Project	IEEE 802.16 Broadband Wireless Access Working Group < http://ieee802.org/16 >
Title	Re-definition of Mobile Terminal Management Primitives
Date Submitted	2007-03-15
Source(s)	Jaesun Cha and Chulsik Yoon jscha@etri.re.kr ETRI 161 Gajeong-dong, Yuseong-gu Daejeon 305-700 Korea
Re:	Contribution on comments to IEEE 802.16g/D8
Abstract	Re-definition of mobile terminal management primitives
Purpose	Adoption
Notice	This document has been prepared to assist IEEE 802.16. It is offered as a basis for discussion and is not binding on the contributing individual(s) or organization(s). The material in this document is subject to change in form and content after further study. The contributor(s) reserve(s) the right to add, amend or withdraw material contained herein.
Release	The contributor grants a free, irrevocable license to the IEEE to incorporate text contained in this contribution, and any modifications thereof, in the creation of an IEEE Standards publication; to copyright in the IEEE's name any IEEE Standards publication even though it may include portions of this contribution; and at the IEEE's sole discretion to permit others to reproduce in whole or in part the resulting IEEE

Figure 505 – M-MTM primitives flow for Reset / Power On /-Power Down at MSSS side

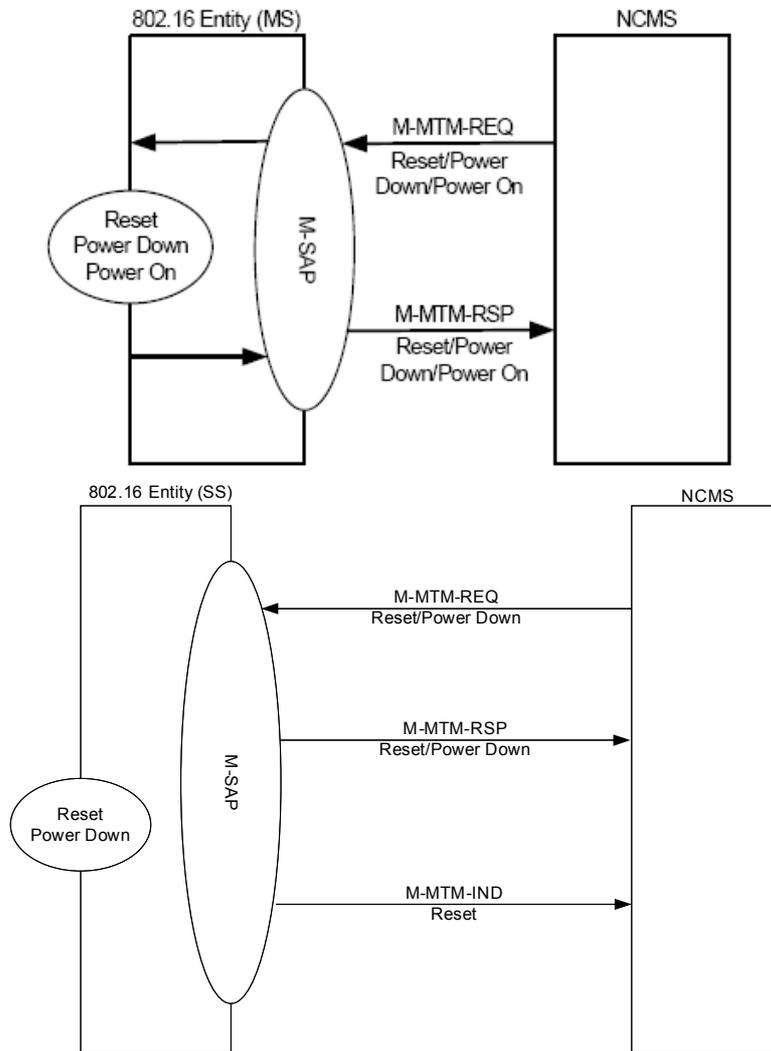
Some of mobile terminal management primitives are not defined correctly. For example, M-MTM-REQ (Power On) primitive is generated to force the terminal to power on. But, the terminal can not receive the primitive because it has already been powered off.

Primitives	Changes	Reason for Changes
M-MTM-REQ (Power on) M-MTM-RSP (Power on)	<ul style="list-style-type: none"> ➤ Remove two primitives ➤ Add a new primitive; M-MTM-IND (Power On) 	<ul style="list-style-type: none"> ➤ We can't give any instruction to the device which is powered off.
M-MTM-REQ (Power Down) M-MTM-RSP (Power Down)	<ul style="list-style-type: none"> ➤ The SS generates M-MTM-RSP (Power Down) primitives before it starts power-down procedure. 	<ul style="list-style-type: none"> ➤ After power-down, the SS can't generate any primitive.
M-MTM-REQ (Reset) M-MTM-RSP (Reset)	<ul style="list-style-type: none"> ➤ If NCMS at SS side generates the request primitive, the SS performs reset procedure after it responds to the request. And then, it generates M-MTM-IND (reset) primitive to notify the NCMS of the completion of reset. ➤ If NCMS at BS side uses M-MTM-REQ (reset) primitive instead of M-MTM-IND (reset) primitive to reset the terminal 	<ul style="list-style-type: none"> ➤ It's better to use one unified primitive to notify the NCMS of a reset event; M-MTM-IND (reset) ➤ The generation of M-MTM-IND (reset) by the NCMS at BS side is not the event notification. It's just a request to reset the terminal

Figure 507 – M-MTM primitives flow for Hold and Normal resumption

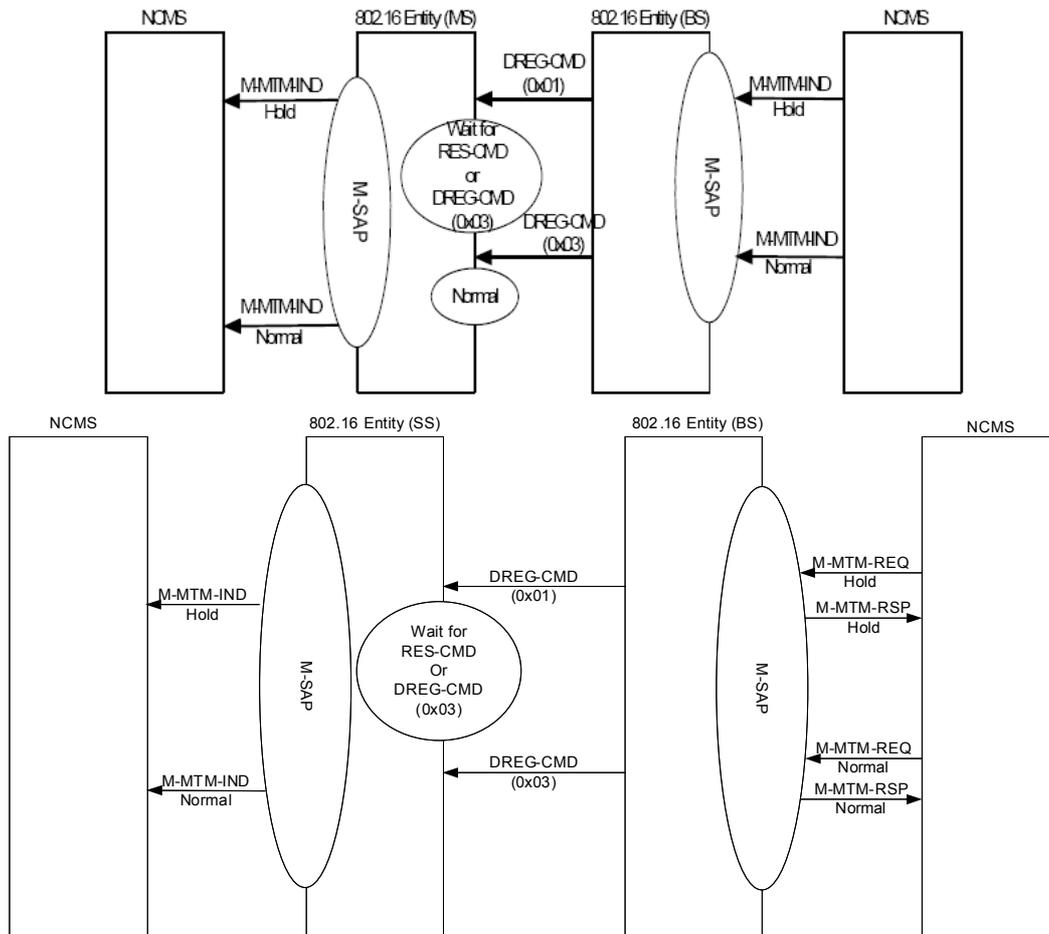
Another example is the primitives used to change the status of the terminal. Generally, an indication primitive is used to notify any event. But, in the current draft, the NCMS uses an indication primitive to request the terminal to change the current status.

M-MTM-IND (Hold)	<ul style="list-style-type: none"> ➤ Only SS can generate M-MTM-IND (Hold) primitive. ➤ The new primitives are used at BS side; M-MTM-REQ (Hold), M-MTM-RSP (Hold) 	<ul style="list-style-type: none"> ➤ The generation of M-MTM-IND (Hold) by the NCMS at BS side is not the event notification. It's just a request to change the status of the terminal
M-MTM-IND (Normal)	<ul style="list-style-type: none"> ➤ Only SS can generate M-MTM-IND (Normal) primitive. ➤ The new primitives are used at BS side; M-MTM-REQ (Normal), M-MTM-RSP (Normal) 	<ul style="list-style-type: none"> ➤ The generation of M-MTM-IND (Normal) by the NCMS at BS side is not the event notification. It's just a request to change the status of the terminal
